12.4 Response to Petition - Beckwith Grove Pedestrian Bridge, Seaford

To respond to the petition regarding reinstatement of Beckwith Grove Pedestrian Bridge in Seaford.

RE: CPTED Assessment – Beckwith Foot Bridge Seaford.

Photo 2 shows Boundary Fencing adjoining 8 & 6 Beckwith Grove.

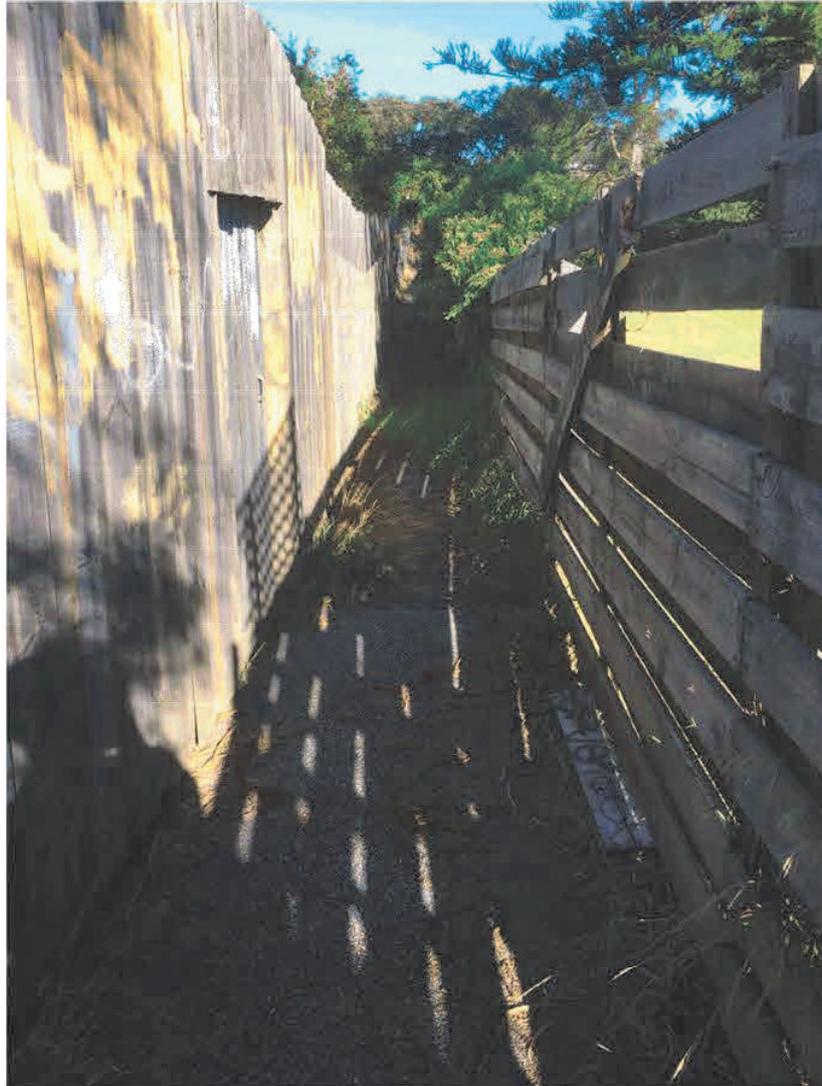
- Entries are current closed to the public with cyclone type fencing
- Boundary fencing is of good height however is currently in a state of disrepair and allows for the public to view in to private property from the foot bridge entries

Photo 3 - Highlights the width of the path and the inability to allow pedestrians to pass each other.

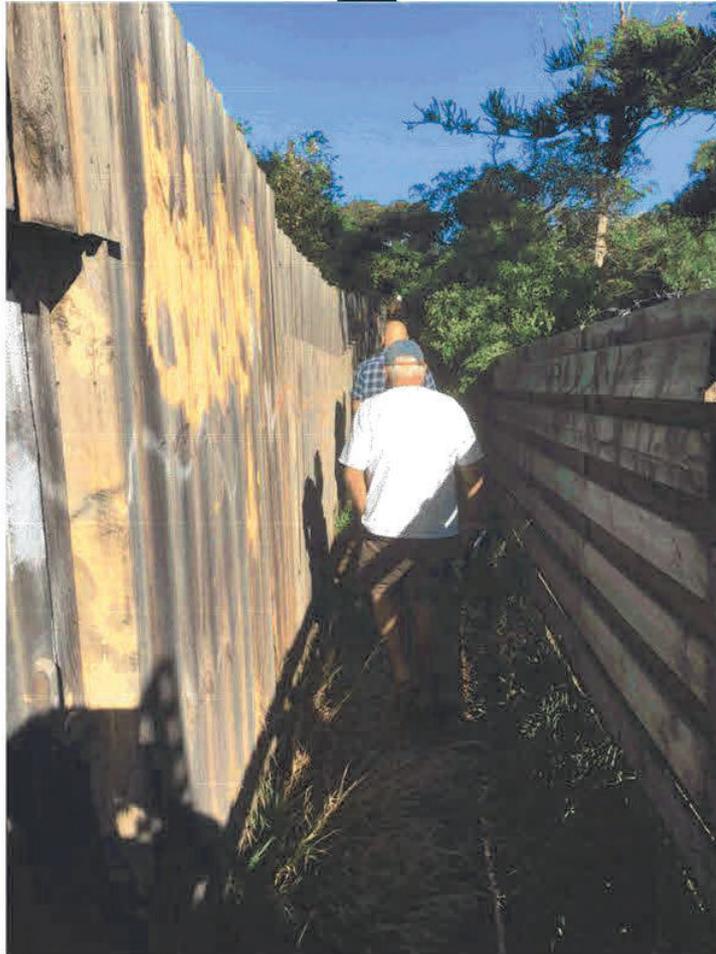
- The area is not fitted with exterior fixed CCTV camera systems.
- The area is not in open space allowing public surveillance.
- The Walkway is only 1.3 Meters wide not allowing foot traffic to pass each other.

NOTE: Graffiti on fences when the walkway was on to the general public.

One Street Light in area

Vegetation allowing for offenders to hide.

- Adequate CCTV be installed that feeds back to the Frankston Police Complex
(Note that due to the width of the walkway this may not be possible)
- No CCTV is to view private property
(Note that due to the width of the walkway this may not be possible)
- Adequate public lighting to be installed.
(Note that due to the width of the walkway this may not be possible)
- Walkway be locked and closed to the general public after dusk every night.
- Vegetation surround walkway be removed and uplifted to allow for public surveillance.
